CERTIFICATE OF APPROPRIATENESS

Property: 1407 Tulane Street, lot 15, tract 14, block 152, Houston Heights Subdivision. The property includes a historic 1,370 square foot, one-story wood frame single-family residence and a detached garage situated on a 6,600 square foot (50' x 132') interior lot.

Proposal: Alteration – Construct a 2,152 square foot two story addition and attached garage at the original rear wall of the contributing one story house. The addition will feature a ridge height of 27'-8" and an eave height of 20'-7".

Recommendation: Partial Approval: Approval of the addition; Denial of alterations to existing front porch columns and front door

EAST ELEVATION – FRONT FACING TULANE

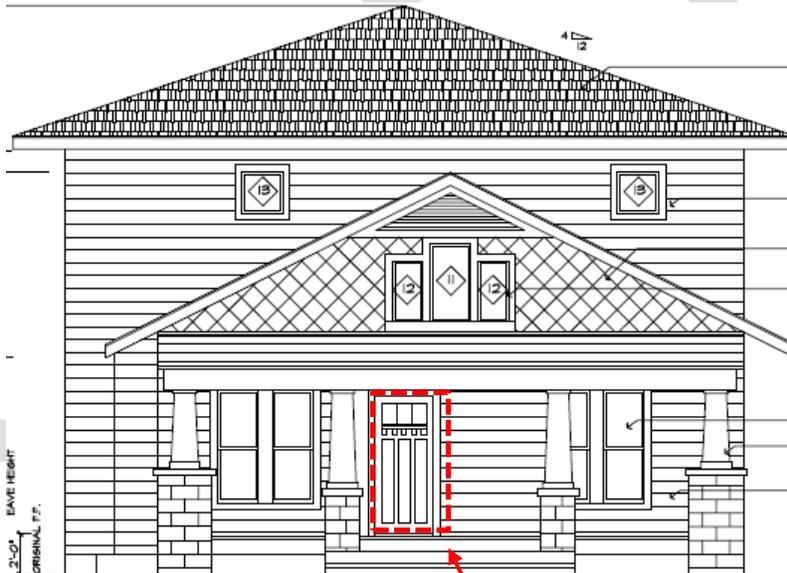
<i>The transitional design of the residence features a mix of Craftsman and Queen Anne elements that, taken together, compose its historic character. Replacing the Queen Anne front door and columns with a Craftsman design diminishes this character.</i> |

<i>The transitional design of the residence features a mix of Craftsman and Queen Anne elements that, taken together, compose its historic character. Replacing the Queen Anne front door and columns with a Craftsman design diminishes this character which was distinct to the particular time period in which the house was constructed.</i> |

<i>The combination of Queen Anne and Craftsman features is a significant contributor to the character of the building. Replacing Queen Anne features (such as the front door) with Craftsman features diminishes that character.</i> |

<i>The front door is a significant piece of historic material and should not be replaced unless damaged beyond repair.</i> |

DOOR TO BE REMOVED AND REPLACED
